UNITED STATES PATENT AND TRADEMARK OFFICE

APPLICATION NO.	FILING DATE	FIRST NAMED INVENTOR	ATTORNEY DOCKET NO.	CONFIRMATION NO.
10/830,120	04/23/2004	Jung-hyun Lee	249/456	9015

Office Action Summary

DETAILED ACTION

Fig. 2

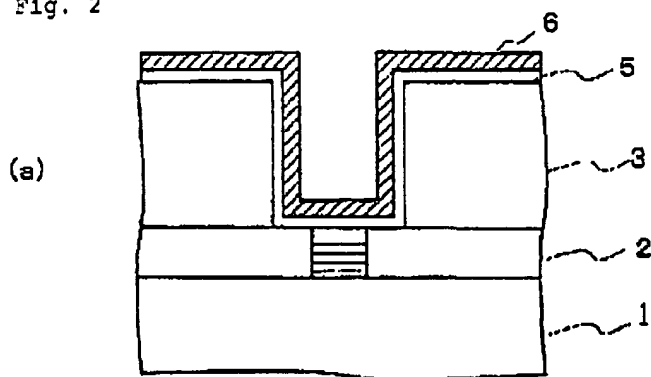
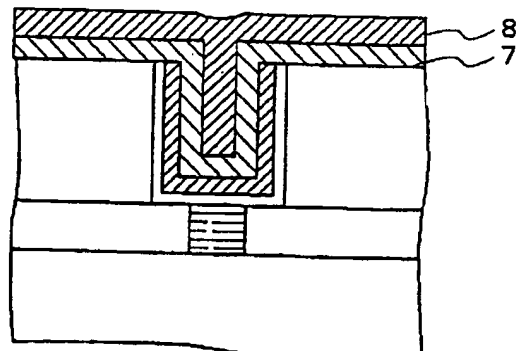
As claim 1 is currently written, the broad claim language does not distinctly exclude the disclosed stack type capacitor structure as shown in Figure 3 of Aoki et al. As shown below layers 5, 6, and 8 are all metal layers that make up an upper and lower electrodes. Either Layer 8 or 6 can be viewed as second metal layer that completely fills in the space defined by the first metal layer 5 and/or 6.

From the interpretation that layer 8 is the second metal layer, as shown in the above figure the first metal layer 6 defines a cylindrical shape. This layer is the lower electrode. This lower cylindrical shaped electrode includes a second metal layer 8 that fills the lower electrode. As the claim is currently worded the lower electrode is not

required to be made of first and second metal layers and therefore does not exclude an additional layer 7 in between.

Additionally, from the interpretation that layer 6 is the second metal layer the adhesive layer 5 can be formed from Wn or Ti which are metal (see paragraph [0034]), and lower electrode metal film 6 fills in the metal adhesive film 5 forming a lower filled in cylindrical shaped electrode formed of contacting/consecutive first and second metal films. A dielectric layer 7 is formed on the first and second metal layers that comprise the lower electrode and then an upper electrode 8 is formed on the dielectric layer. Thus Aoki meets all of the claim limitations.

Fig. 2

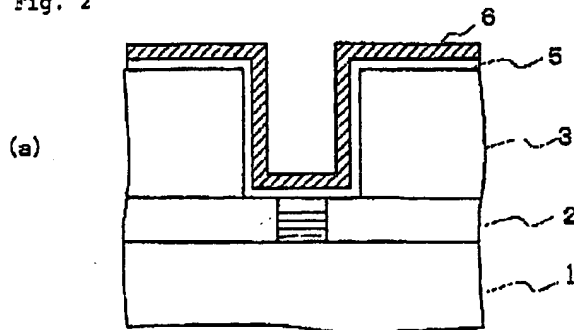
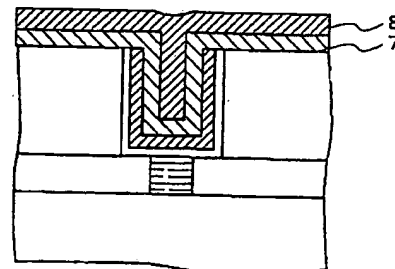
Regarding claim 1, Aoki et al. discloses a stack-type capacitor comprising:

a lower electrode; (Aoki et al., Fig. 2 ref #'s 5&6)

a dielectric layer formed on the lower electrode; (Aoki et al., Fig. 2 ref # 7)

and an upper electrode formed on the dielectric layer, (Aoki et al., Fig. 3 ref # 8)

a first metal layer having a cylindrical shape and defining a cylindrical space; and (Aoki et al., Fig. 2 ref # 6)

a second metal layer completely filling the cylindrical space defined by the first metal layer (Aoki et al., Fig. 3 ref # 8)
